KMR.CDD.JmQ.1940-1942.01

BUILDING COMPLETION REPORT

AMENDED
PLAN SHOWING PROPOSED FIRST FLOOR
ON PLOT No. 68. SHEET No. J.M.1.
JAMSHED QUARTER
SCALE 8"=1."

PLATFORM

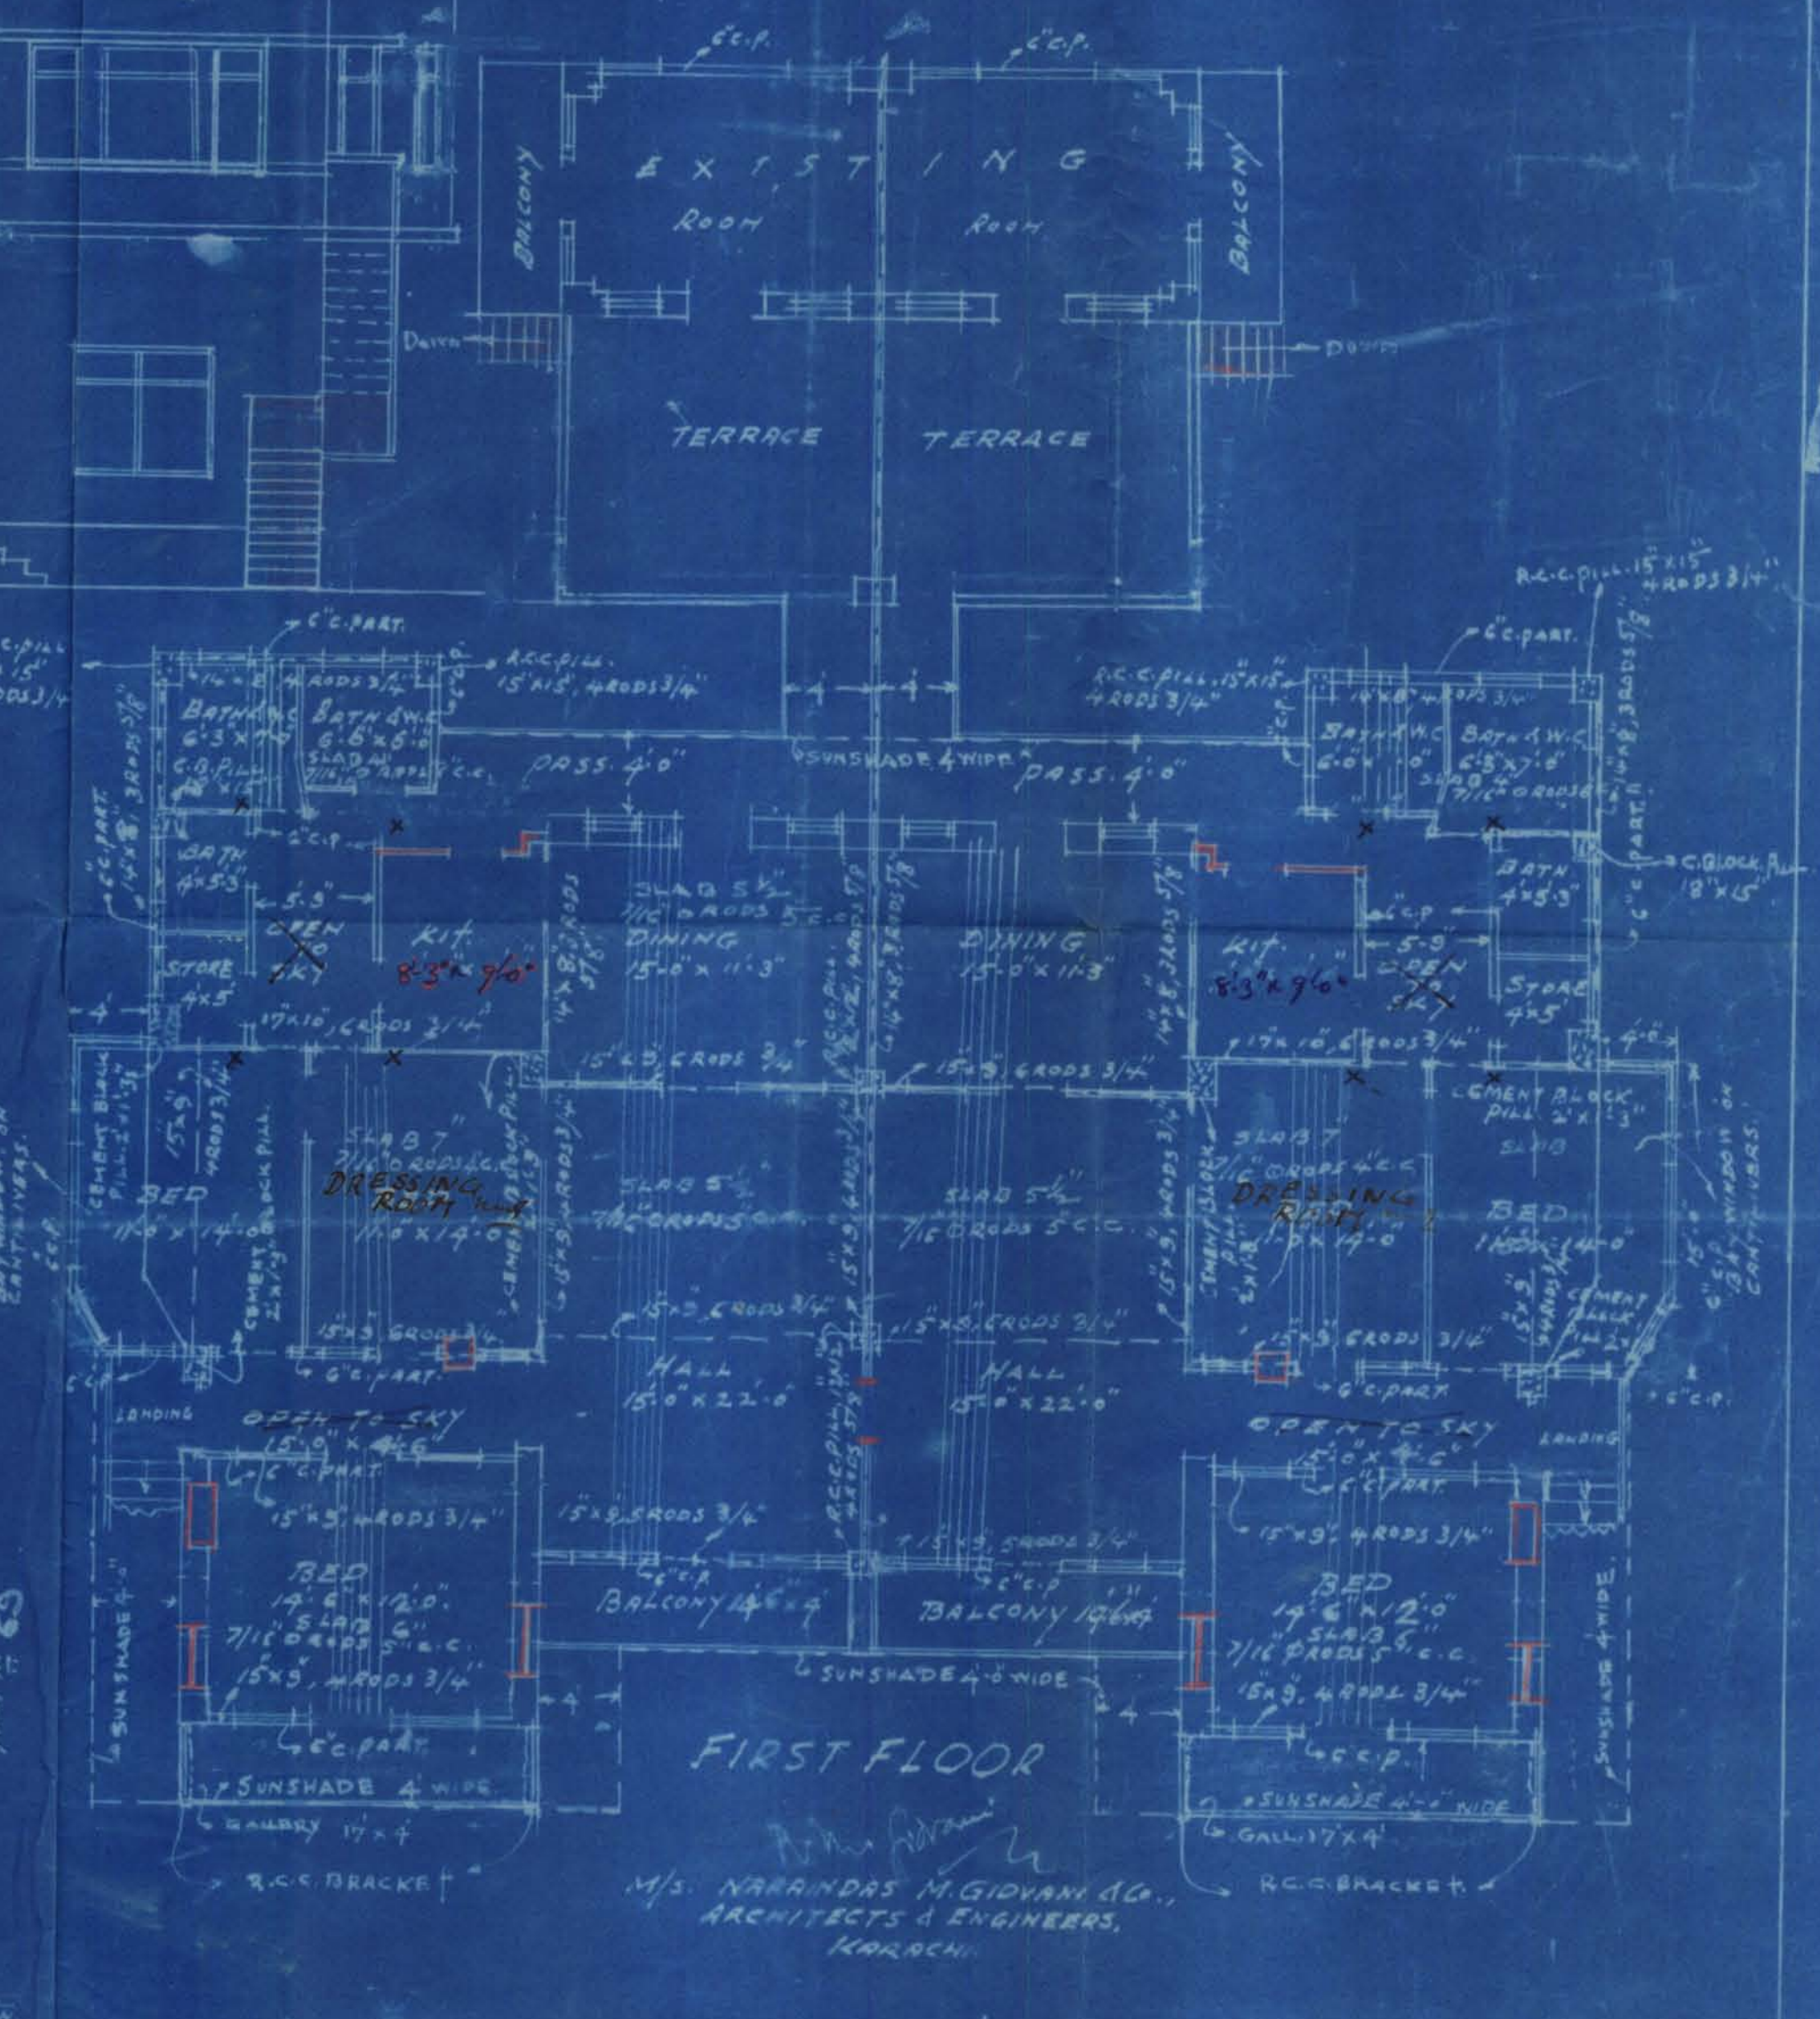
- (1) Coverings over areas which were open to sky to be shown as constructed.
- (2) Balconies to the terrace must be shown together with courtyard. They cannot be allowed in the open area.
- (3) Sink in compulsory open space to be removed.
- (4) Coverings cannot be allowed over the areas originally open to sky cannot be allowed. They also render the central bed rooms dark.

- (1) Coverings over areas which were open to sky to be shown as constructed
- (2) Balconies to the terrace must be shown together with courtyard. They cannot be allowed in open area
- (3) Sink in compulsory open space to be removed
- (4) Submitted.

On the first floor areas open to sky have been covered with roof which is about 8 ft. higher than the general level of ^{the} roof, as shown in the plan. Orders are requested if these coverings be allowed & whether the central Bed-rooms would be permissible.

Objection No. 1. is complied with.

Reg. Objection No. 2. Balconies to the terrace have already been approved in the original approved plan. The only change is that the position of 2'-0" wide stairs has been changed from one side to the other. We might add that in this plot long galleries in the court yard have already been allowed in free area. Court yard wall has been existing since the beginning. It has been shown in the ~~plan~~ plan.

Objection No. 3. Door and roof to the sink have been removed.

Objection No. 4. The covering over the existing open to sky ~~area~~ are intended as a protection from rain ~~in~~ etc.

Besides they are high with the sides open to admit of light and breeze.

The central rooms are not dark. Therefore they may kindly be allowed and plans approved.
